City of Richmond
Urban Development Division

Report to Development Permit Panel

To: Development Permit Panel
From: Joe Erceg
Manager, Development Applications
Date: February 12, 2003
File: DP 02-219529
Re: **Application by ASP Architects Inc. for a Development Permit at
8220, 8240 Garden City Road and 9020, 9040 Dixon Avenue**

DRAWING TITLE:
SITE PLAN

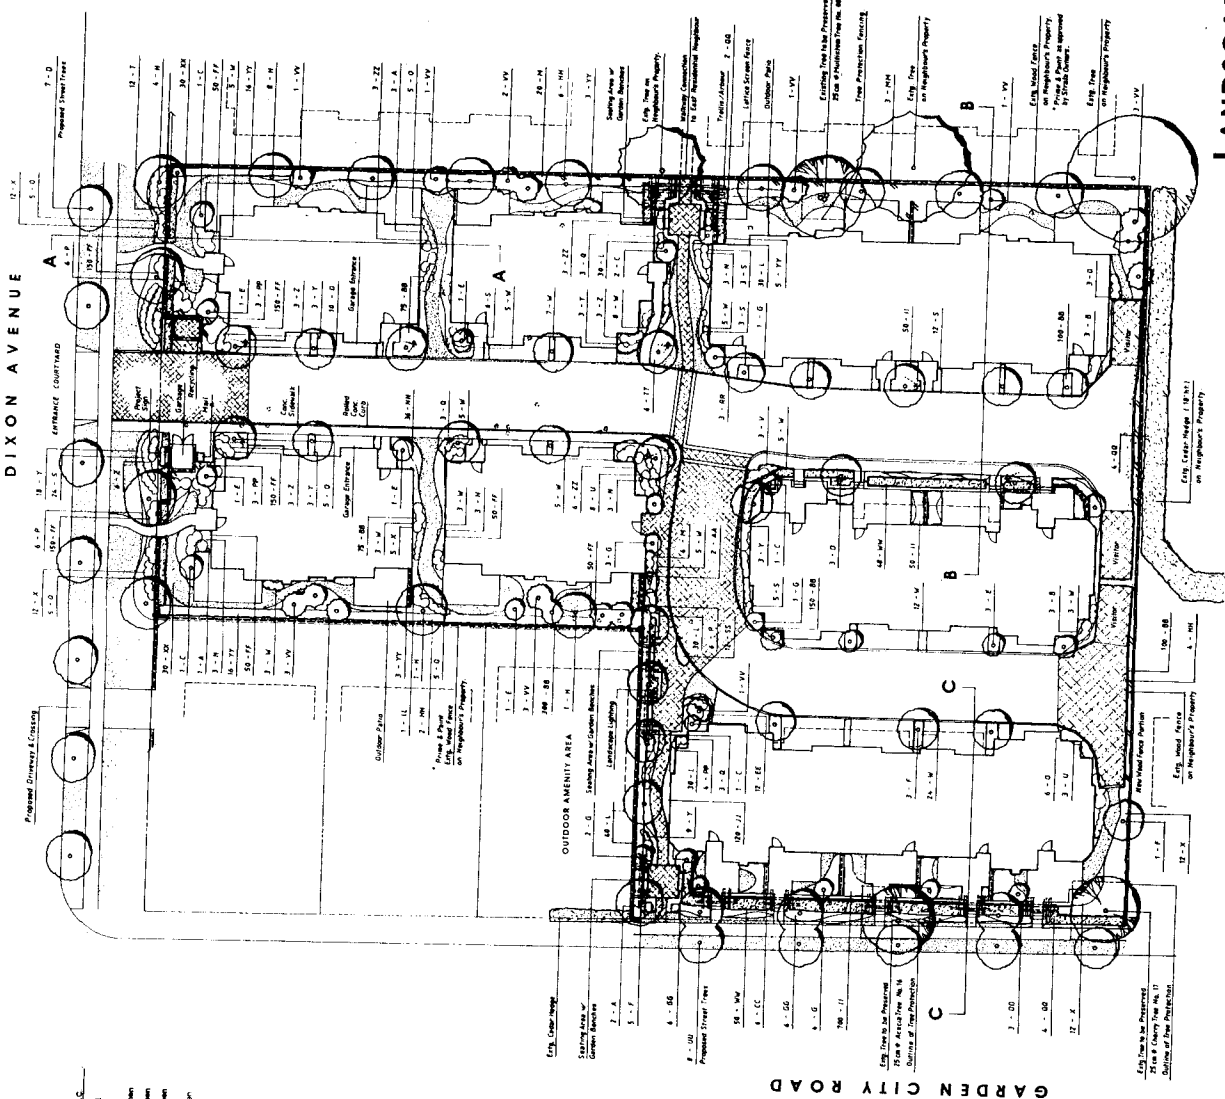
VARIANCE REQUEST for
PROVISION OF GARBAGE
RECYCLING AND MAILBOXES
WITHIN DIXON AVENUE
FRONT YARD SETBACK

VARIANCE REQUEST for
FRONT YARD SETBACK
DIXON AVENUE
REQUESTED 5.0m FROM 6.0m
GARDEN CITY ROAD
REQUESTED 5.0m FROM 6.0m
UP TO 50% OF FACADE
